M E M O R A N D U M

March 2nd, 2016

SUBJECT: Public hearing and consideration of a Landmark Alteration Certificate application to demolish an existing house built in 1957 and, in its place, construct a new 2,266 sq. ft. house at 2110 4th Street in the Mapleton Hill Historic District, per section 9-11-18 of the Boulder Revised Code (HIS2015-00254).

Figure 15. Proposed Site Plan

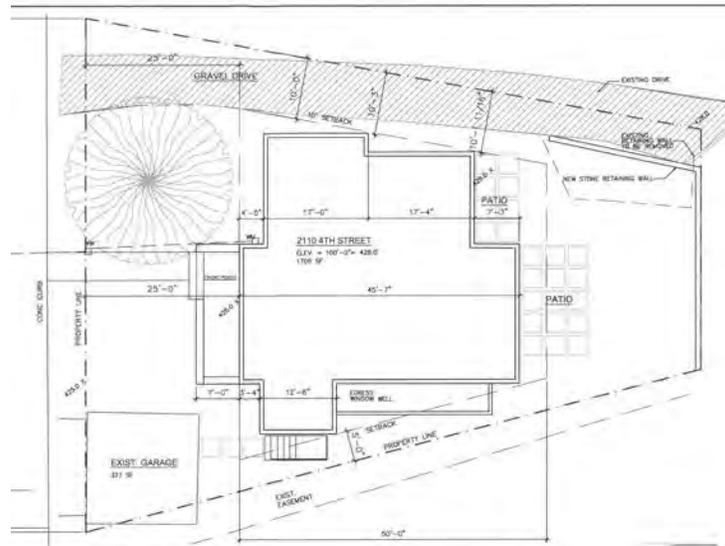
In plan, the proposed new house is shown to be located at approximately the same location as the existing house. The existing house is located approximately 26' from the west property line and the proposed house is shown to be located at the 25' front yard setback. The existing house measures approximately 35' wide and 26' long, with a 21'

by 8' shed-roof portion located at the rear of the house. The proposed house is shown to measure 45'-7" long and approximately 49' wide with the north wall creating an oblique angle to the north property line which runs adjacent to the Farmer's Ditch. Currently, the driveway provides access to at least one property to the east, although there is no dedicated easement providing that access. The existing contributing garage is shown to be maintained in its current location. The proposed shed at the east edge of the property has been removed in this scheme.

The site plan indicates construction of rear retaining walls. No information was provided as to whether any changes to the contributing garage are contemplated as part of this project.

Proposed lower level

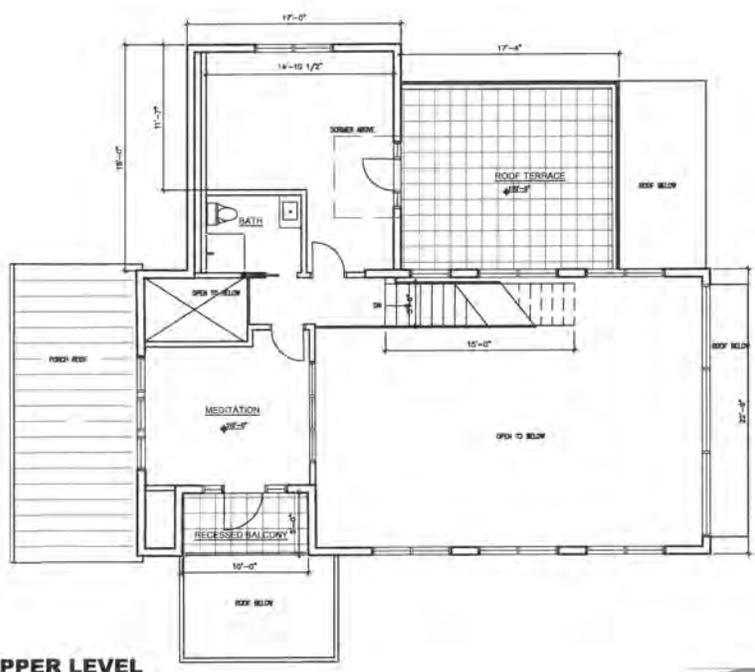
The first floor of the façade (west elevation), is shown to be fenestrated with ¾ light door on the porch and a set of one-over-one double hung sash and pairs of similar windows on the west face of the north and south portions of the house. A set of three one-over-one double hung sash is shown on the west upper-gable. A light-well is indicated at the north end of the west elevation, however, this feature does not appear on site or floor plans. Likewise, a basement window on the south ell on the west face is shown to rise several feet above grade, but a window well in this location is not shown in plan.

Proposed west (façade) elevation

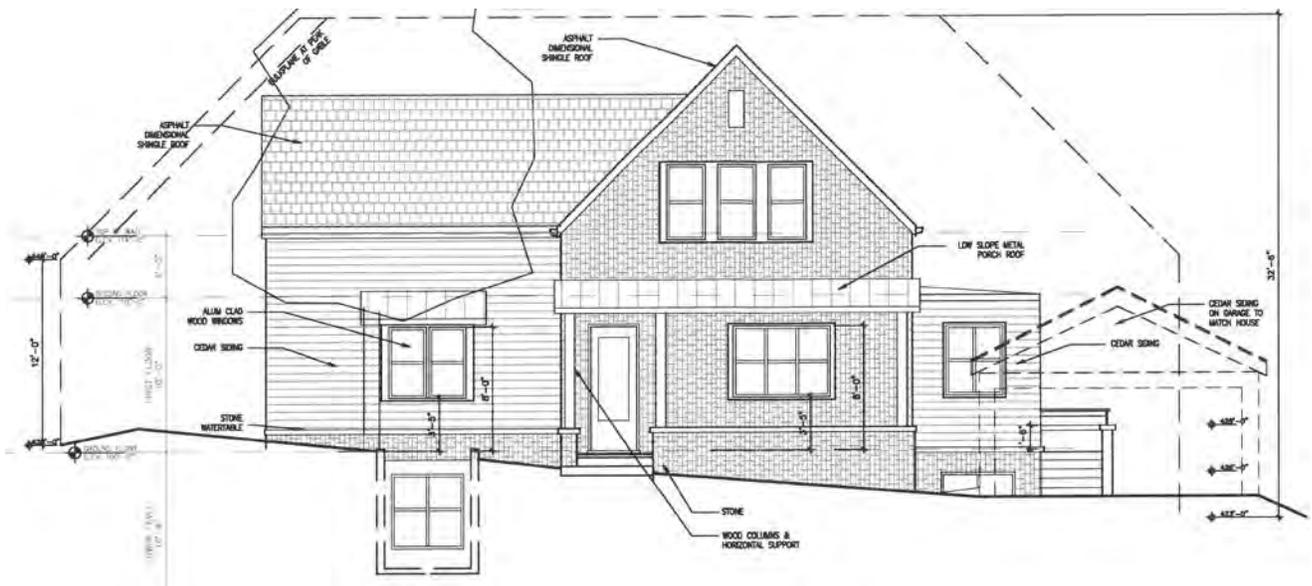
Staff considers that that the design of the casement and narrow double-hung windows at the south and east elevations be further revised to ensure consistency with guidelines. Staff also considers that the material palette should be revised to reflect traditional materials, including painted wood.

1. **Window-wall proportion:** Revise design so that the north, and west elevations have a traditional window to wall proportion (avoid large blank walls); consider revisions to reduce amount of blank wall on the façade (west). K. Remley referenced, Section U.8 of the *Mapleton Hill District Design Guidelines*.

2. **Windows:** Ensure that all windows are traditionally proportioned, scaled and profile, and that there are fewer types (shapes) of windows used (including redesign of redesign of the clerestory windows at the north and south). Consider reducing amount of glass at east face.

3. The Landmarks design review committee shall review details for the building, including dormers, wall materials, fenestration patterns on the front, north and south elevations, doors and window details including moldings, and proposed insets, paint colors, and hardscaping on the property to ensure that the approval is consistent with the *General Design Guidelines* and the *Mapleton Hill Historic District Guidelines* and the intent of this approval.
